Community Development Authority MEETING AGENDA

August 3, 2023 - 8:00 AM
Council Chambers
3805 S. Casper Dr.

A. (2) KH LD-2301013 DreamPak - 17100 W. Ryerson Road – 1-Lot Certified Survey Map

The following comments reflect staff review of the civil plans dated 5/19/23 and the plan of operation dated 7/24/23. Staff has not reviewed the revised civil plans dated 7/24/23:

C3.0

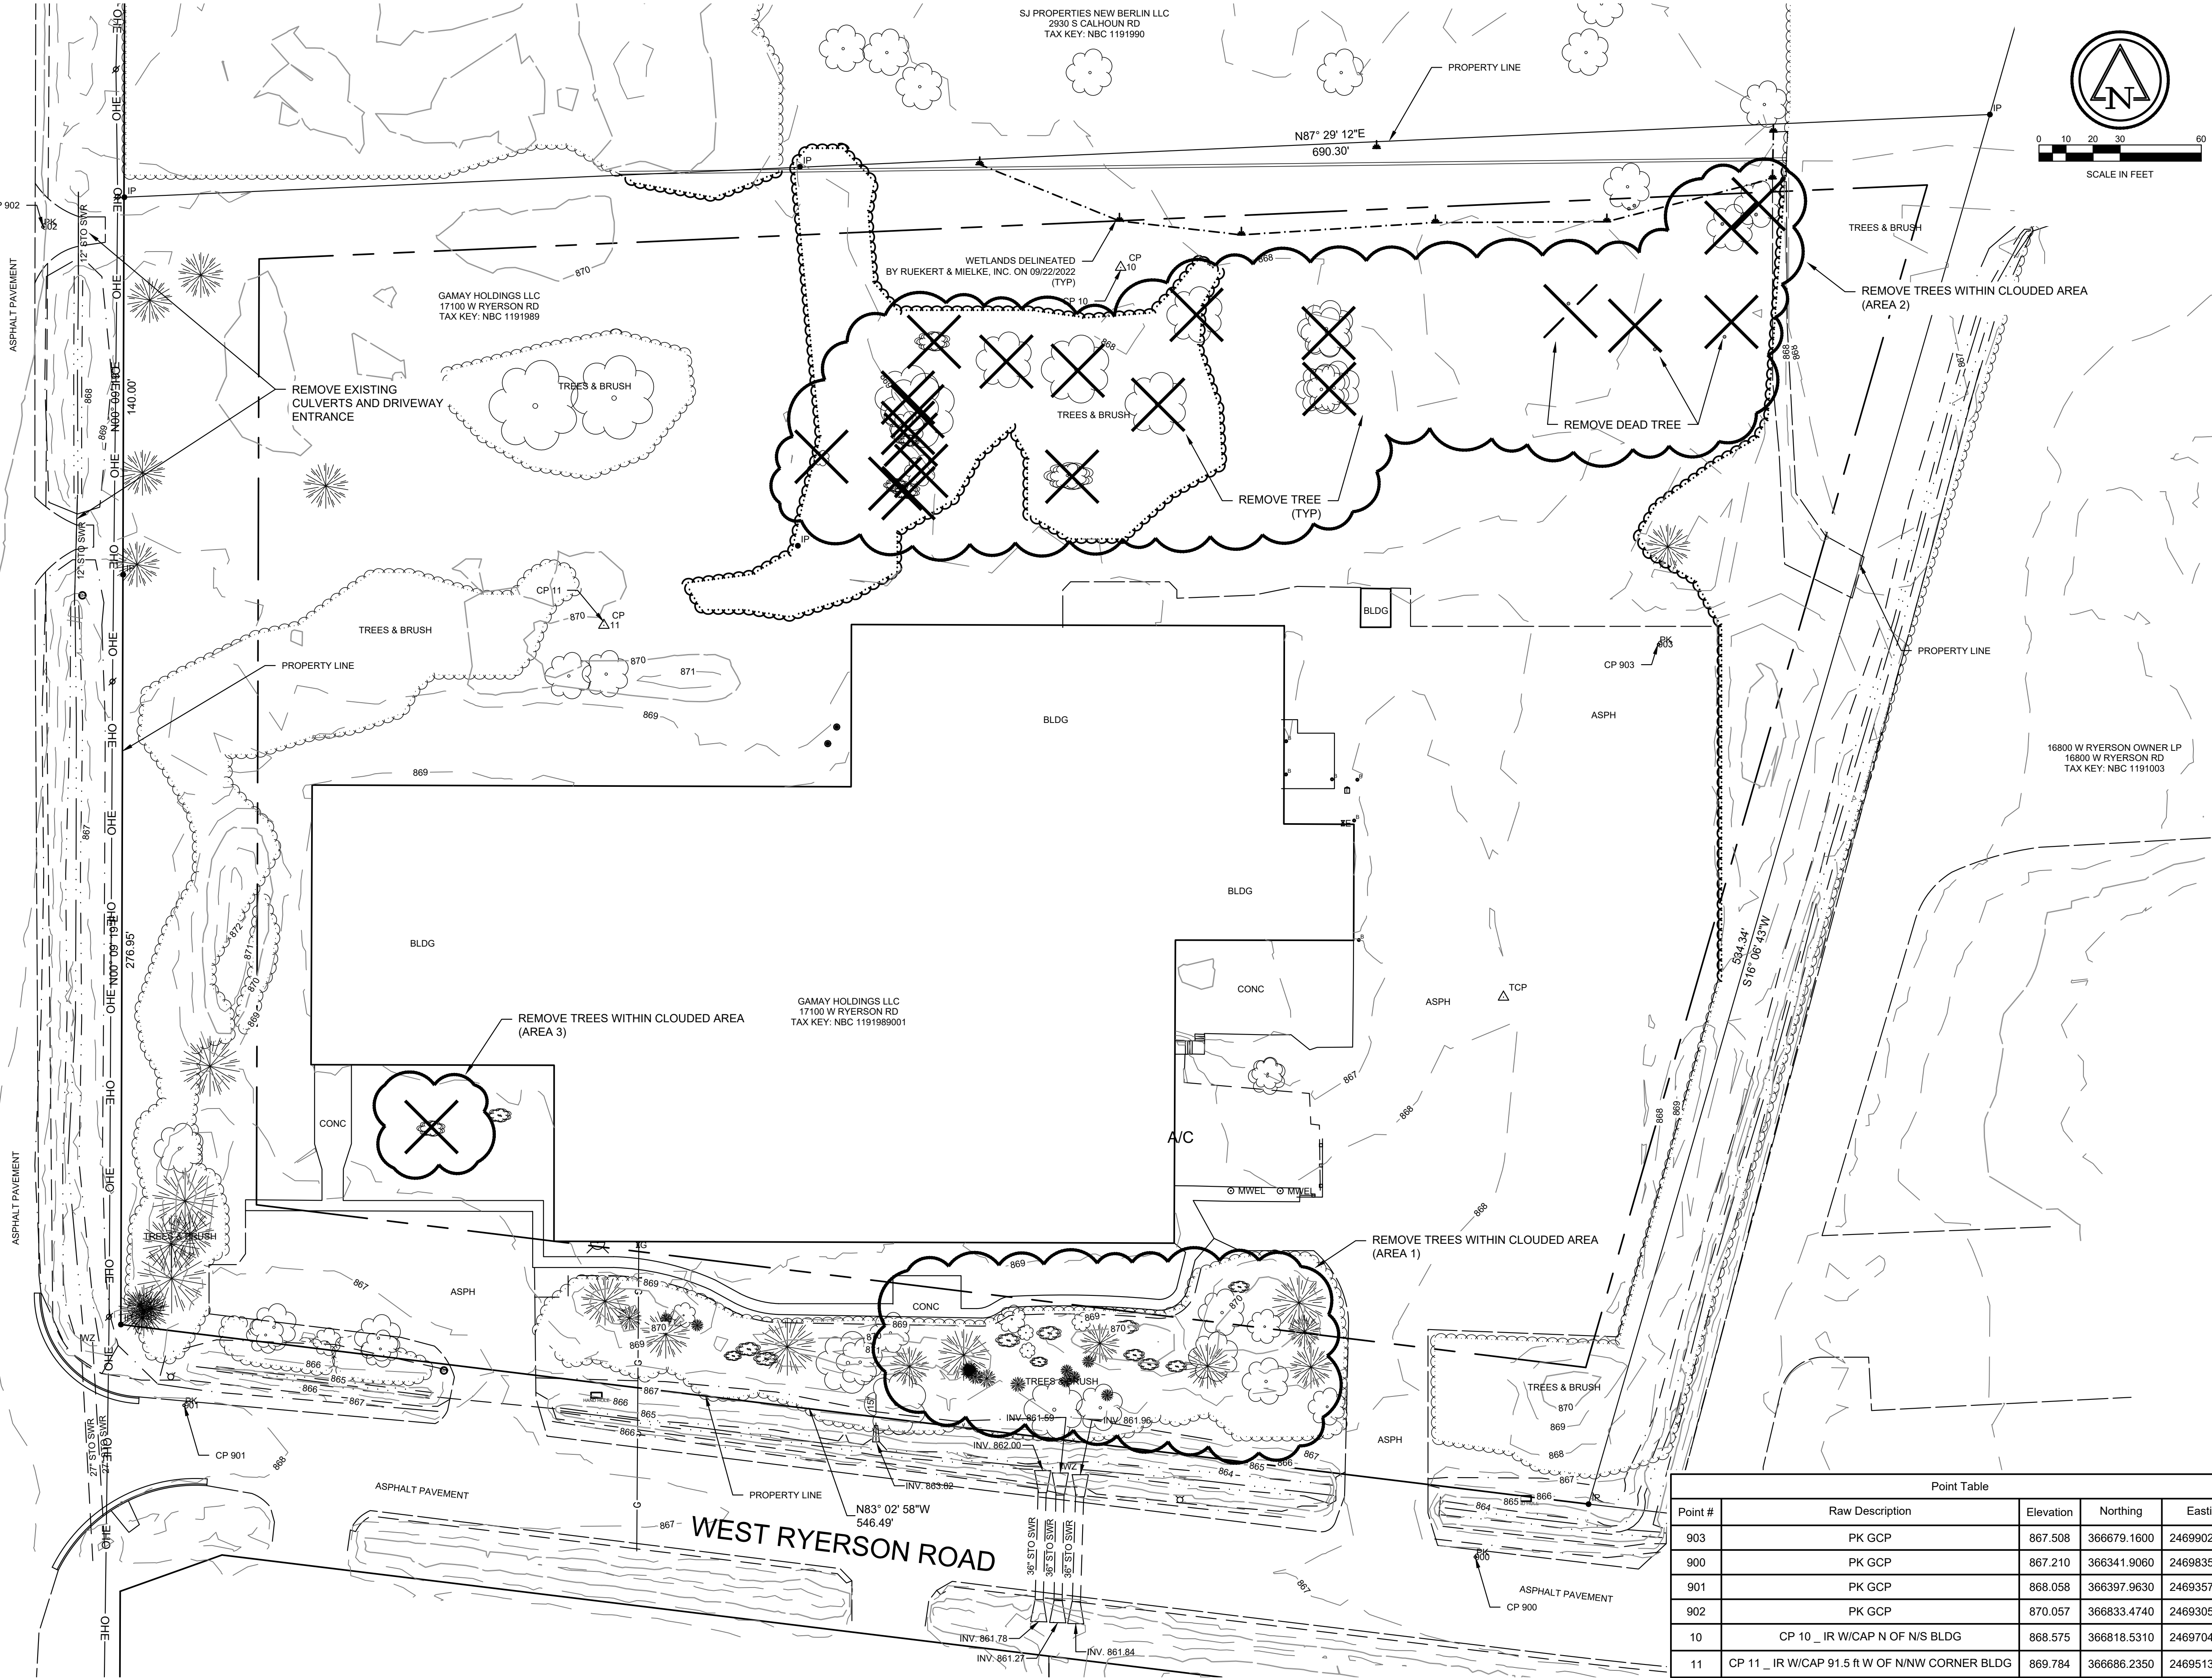
- c. Civil plans shall be revised to show proposed property lines after acceptance of 1-lot CSM, see File #: LD-2301013.
- d. Sheet C3.0 shall be revised to show current number of parking stalls, including parking calculations.

- e. Sheet C4.0 shall be revised to show lot coverage data after acceptance of 1-lot CSM, see File #: LD-2301013.
- f. Applicant shall comply with the tree replacement schedule outlined in §275-54B(6) of the Zoning Code, or pay the City the remainder of the balance to be placed in the landscaping account to plant landscaping elsewhere within the City. Provide information on the condition of the trees to be removed in the table on Sheet C3.0.
